County of Albemarle
Community Development Department

MEMORANDUM

TO: Architectural Review Board
FROM: Khris Taggart, Sr. Planner I
RE: ARB2024-71/SP2024-25 400 Rio Rd. W Concept Plan Revisions
DATE: March 3, 2025

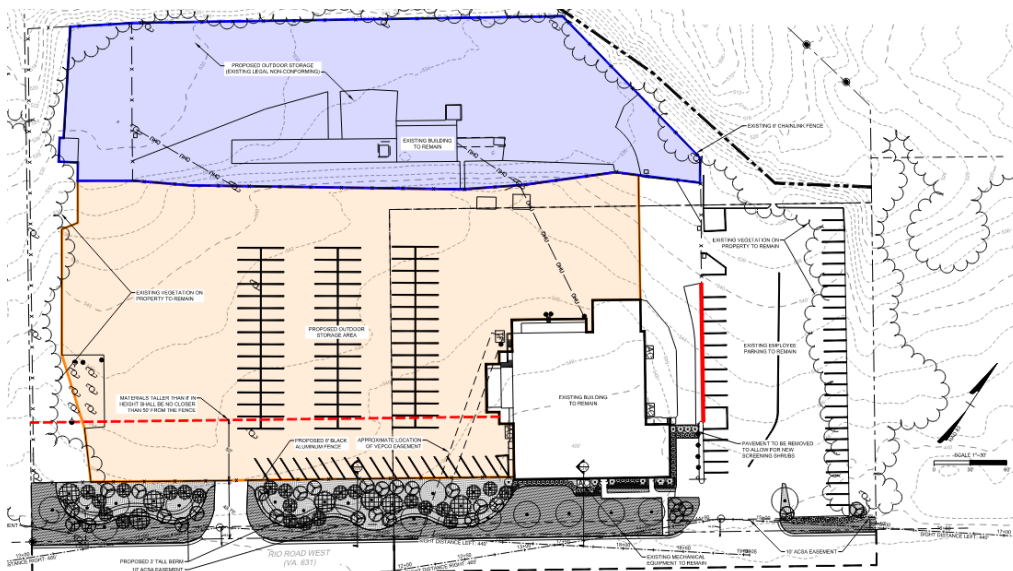
2. The concept plan shows the proposed storage area near the north corner of the building outside of the fenced area. This part of the proposed storage area should be deleted from the proposal.

4. The Zoning Division has indicated that the non-conforming storage area should be brought into conformity with this proposal. This might be accomplished with appropriate fencing and additional planting east of the building. A rendering showing this area from the street would be helpful.

- The concept plan has been revised to show that the existing chain link fence between the employee parking lot and the building near the parcel's frontage will remain in place. The plan also shows that the eastern boundary of the proposed outdoor storage area has been shifted to align with the north corner of the existing building. This resolves the discrepancy from the previous plan.

- The revised concept plan shows pavement east of the building closest to the frontage being removed to accommodate screening shrubs and shrubs being added to the frontage planting area east of the entrance to the employee parking lot. This landscaping is expected to reduce visibility of the non-conforming storage area; however, the storage area will still be visible from the EC from the employee parking entrance when vehicles are not parked in that lot. Revising the plan to show screening shrubs along the fence line between the building and the employee parking lot (highlighted in red below) could help further reduce the visibility from the EC of the non-conforming storage area.
